## Memorandum

To	<b>Ben MacGibbon - Lincoln Land Limited</b>	From	<b>Regan Smith</b>
Copy		Reference	<b>523406</b>
Date	<b>2023-03-20</b>	Pages (including this page)	<b>2</b>
Subject	<b>Groundwater Information – Proposed Retirement Village Development – 1506 Springs Road, Lincoln</b>

Figure 17: piezometric surface derived from Davis Ogilvie and Aurecon Test Pits, image from Canterburymaps.govt.nz. CL area in SE corner is not included due to limited testing.

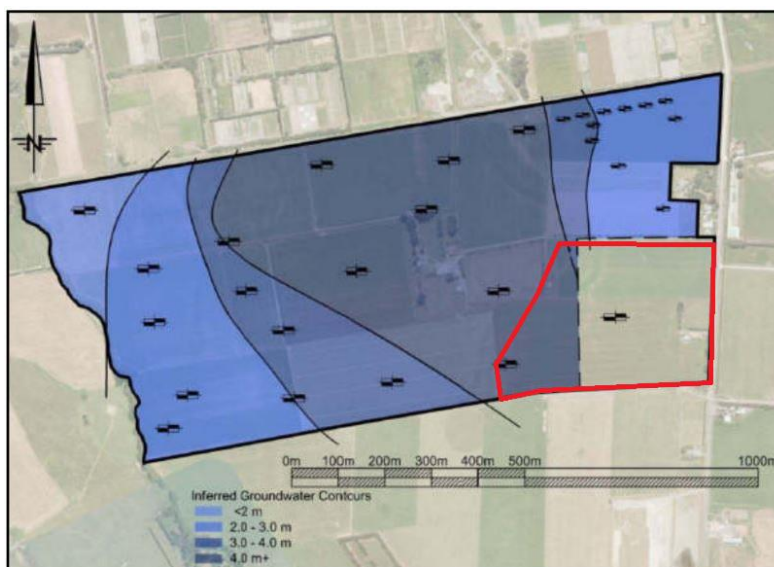
This memo has been prepared to address the question from Environment Canterbury with regard to the potential for stormwater infrastructure to intercept and “take” groundwater.

The following figure has been sourced from the 2018 Davis Ogilvie report and illustrates the estimated groundwater depth derived from various geotechnical investigations. The approximate outline of Site has been sketched in “red” onto the figure for context. This indicates that the groundwater is expected to be greater than 4m depth at the west and south of the Site.

The stormwater basins and associated outlets would need to intercept groundwater for there to be at risk of “taking” groundwater. The basins will be in the order of 1.5-2.0 m below existing ground level which is above the expected groundwater level.

This is further validated by the fact that the existing soakage-based stormwater facility functions as expected and there is no evidence that it, or swale along the western side of the Site, intercept groundwater.
